To: T10 Technical Committee  
 From: Rob Elliott, HP (elliott@hp.com)  
 Date: 19 July 2006  
 Subject: 06-263r4 SAS-2 Spread-spectrum clocking

**Figure 32 — Transmit data path in a SAS phy**

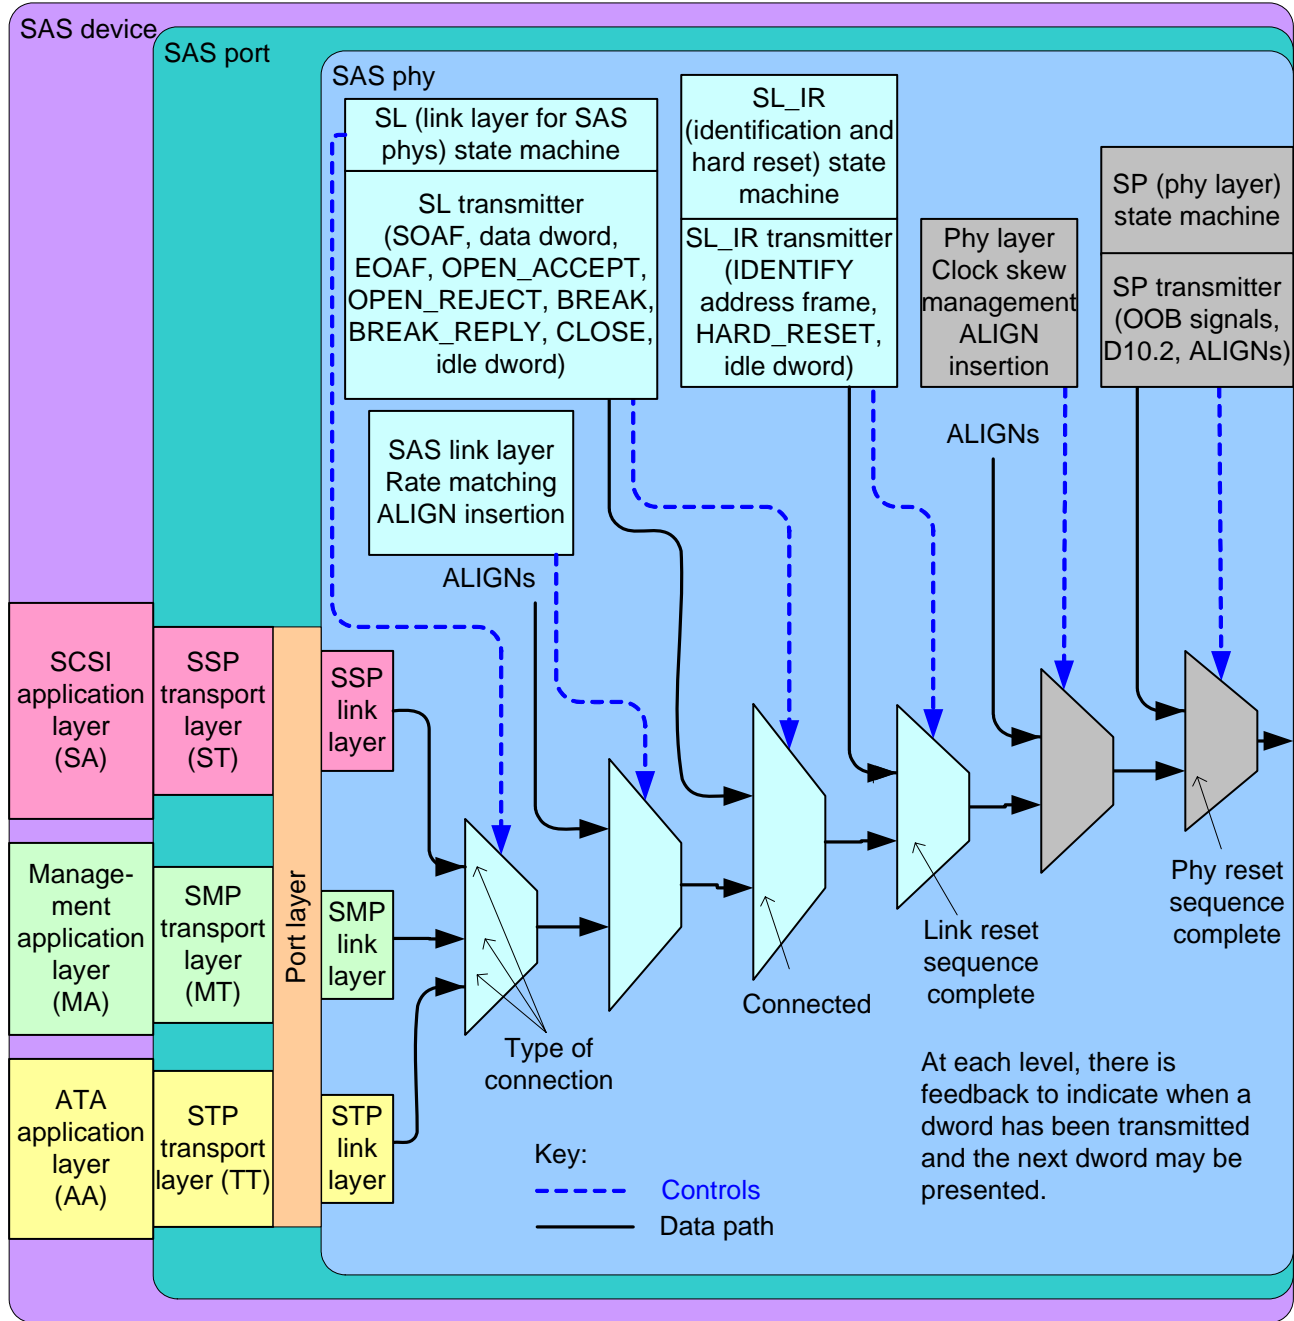
Editor's Note 1: In figure 32, change "Clock skew management" to "Physical link rate tolerance management". Note that 05-381(Multiplexing) also makes changes to this figure.

**Figure 33 — STP link, port, STP transport, and ATA application layer state machines**

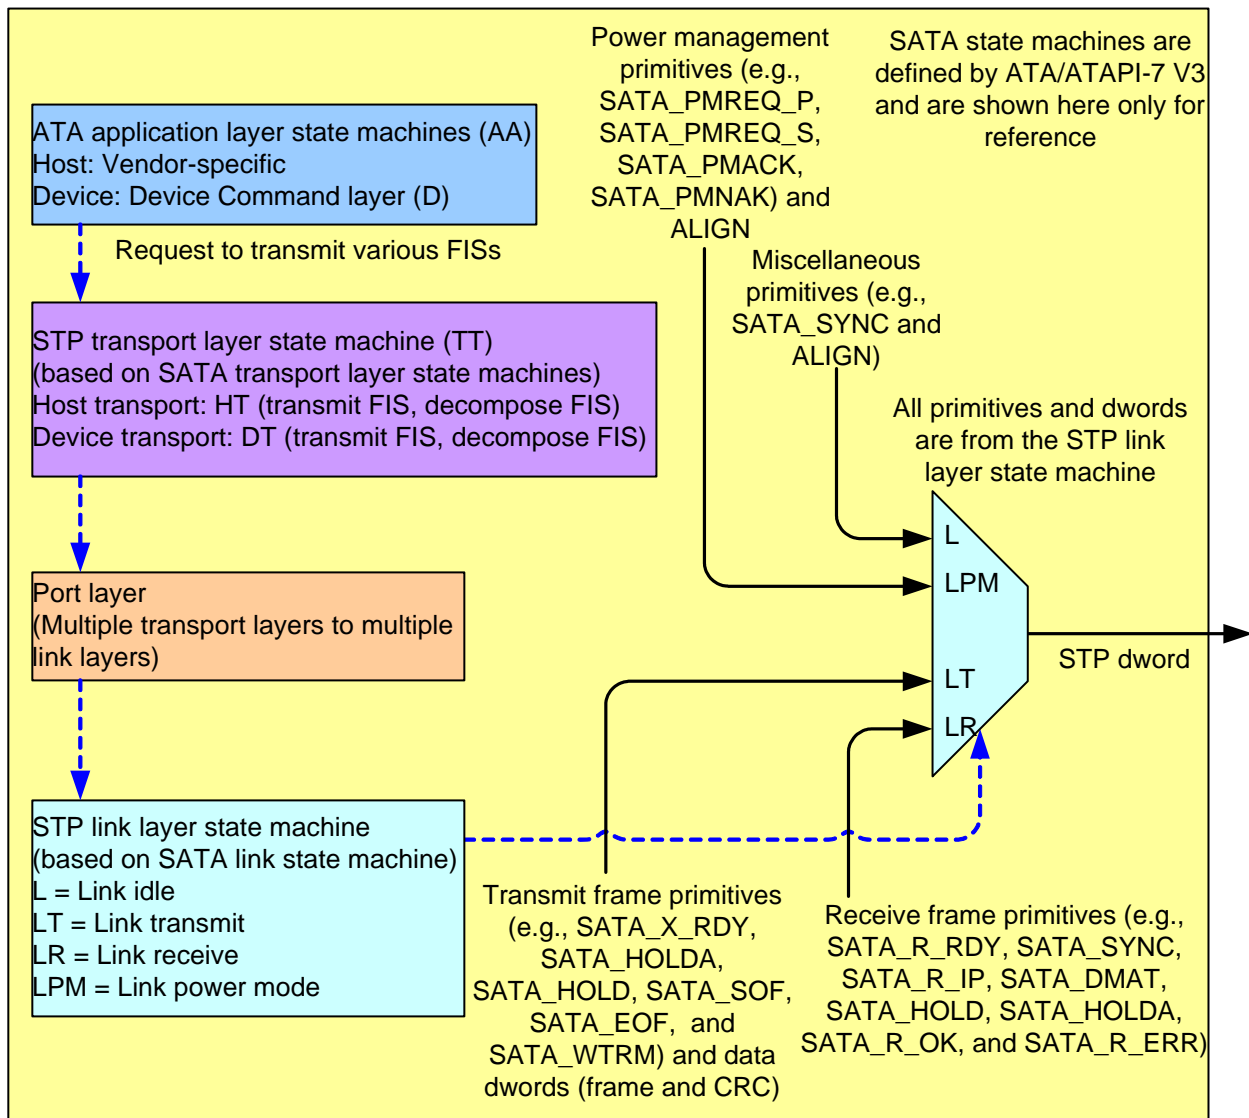
Editor's Note 2: Figure 33 should have included STP initiator phy throttling ALIGN insertion. If the fixed 1/64 ratio for all types of connections is used instead per this proposal, that is no longer a special case.

Figure 36 — Transmit data path and state machines in an expander phy

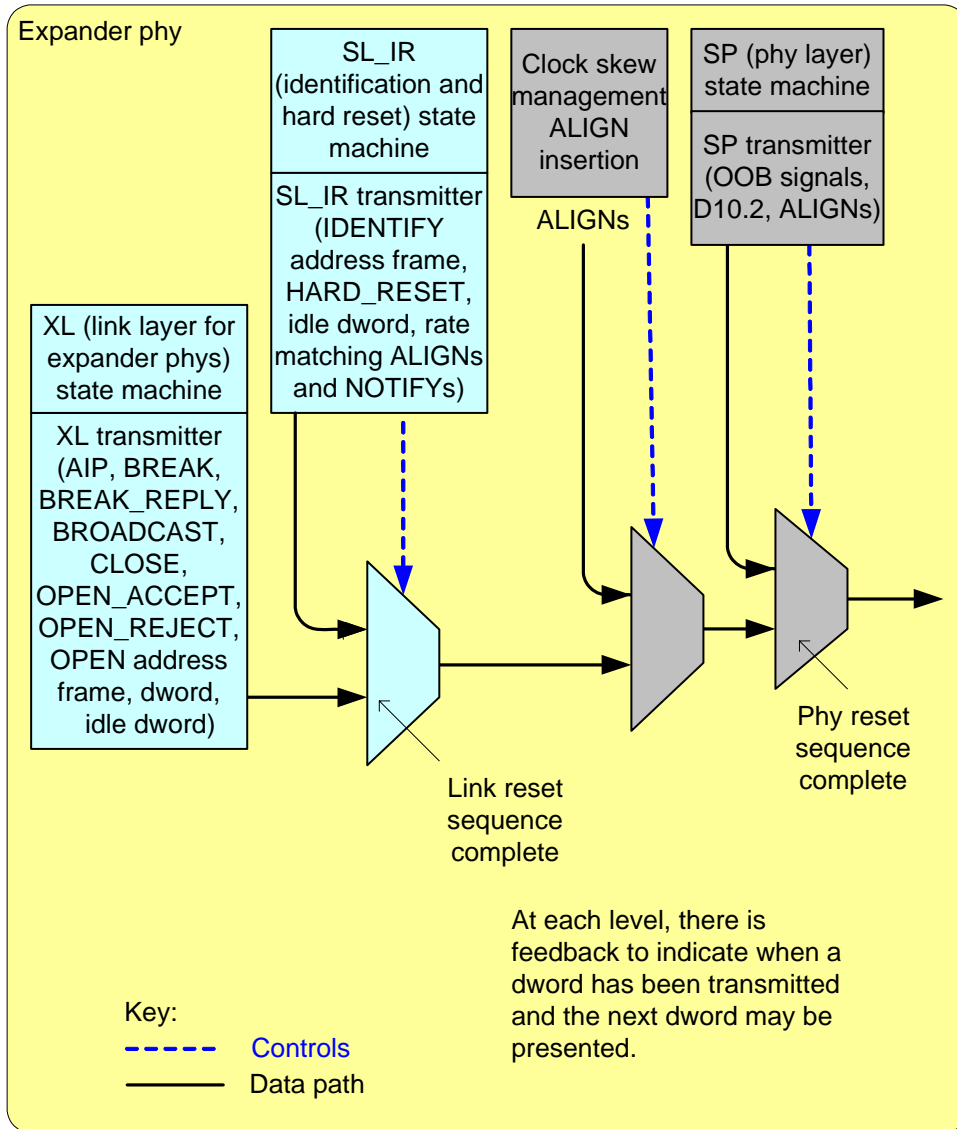
Editor's Note 3: In figure 36, change "Clock skew management" to "Physical link rate tolerance management". Note that 05-381(Multiplexing) also makes changes to this figure.
